**APPROVED**  
Unauthorized work may occur.  
Permit holder responsible for full compliance with the code.

**Caviness Building and Development Company**  
ELEVATIONS

PLAN NO. CL 3067 **A**

1 FIRST FLOOR PLAN  
1/4" = 1'-0"

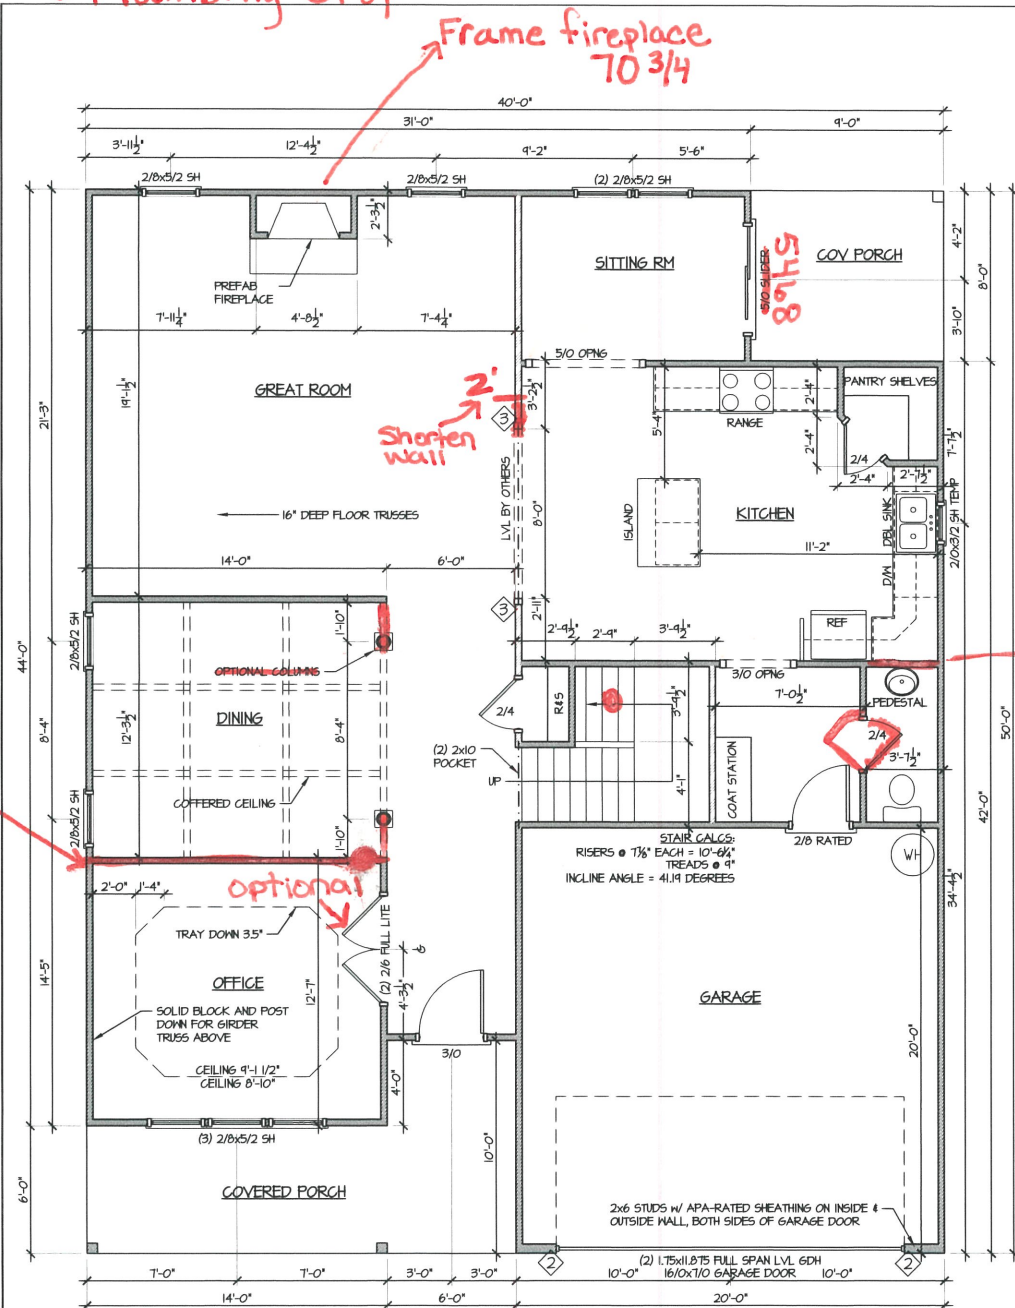
● Plumbing drop

Frame fireplace  
70 3/4

Shorten wall
